7th July 2017

Our Ref: Rinltr8

**RE: APPLICATION TO MODIFY DEVELOPMENT CONSENT (SECTION 96),
DEVELOPMENT APPLICATION NO 42409/2012,
LOT 2 DP:362339, 620 WISEMANS FERRY ROAD, SOMERSBY, NSW**

Plan No. SBMG01570-04

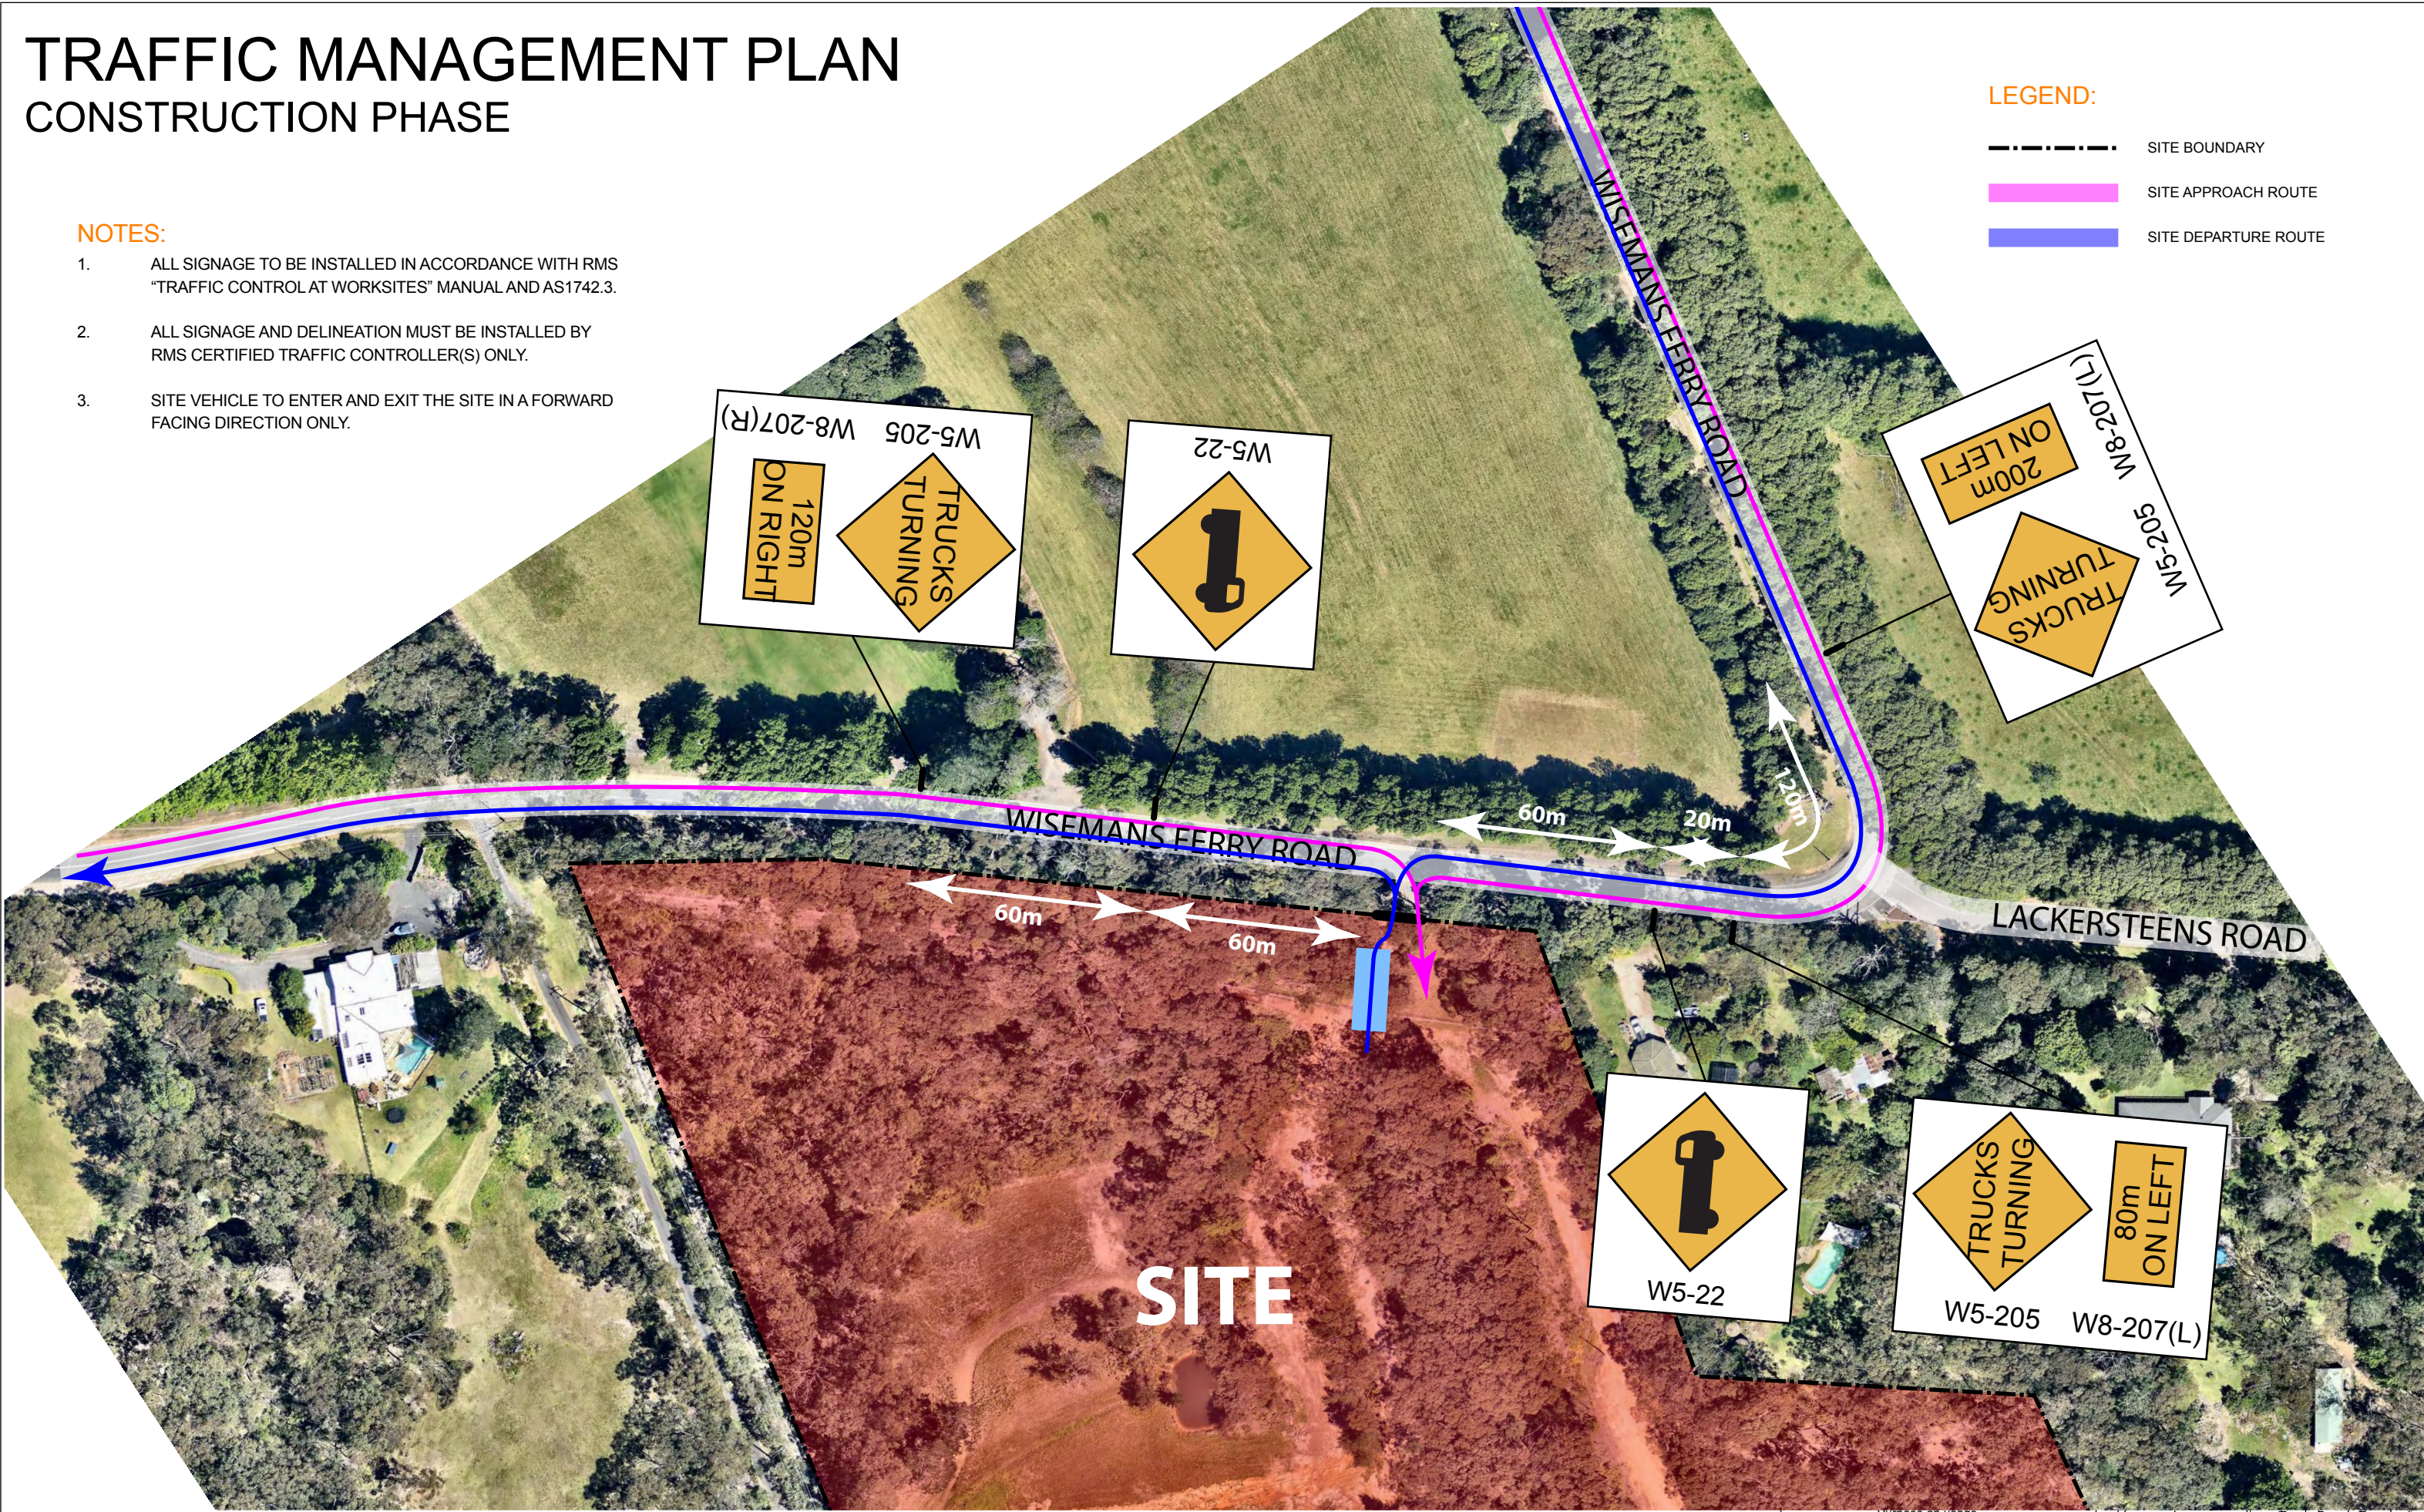
2. Councils Letter Point 3.

Refer to noise/traffic management plan enclosed.
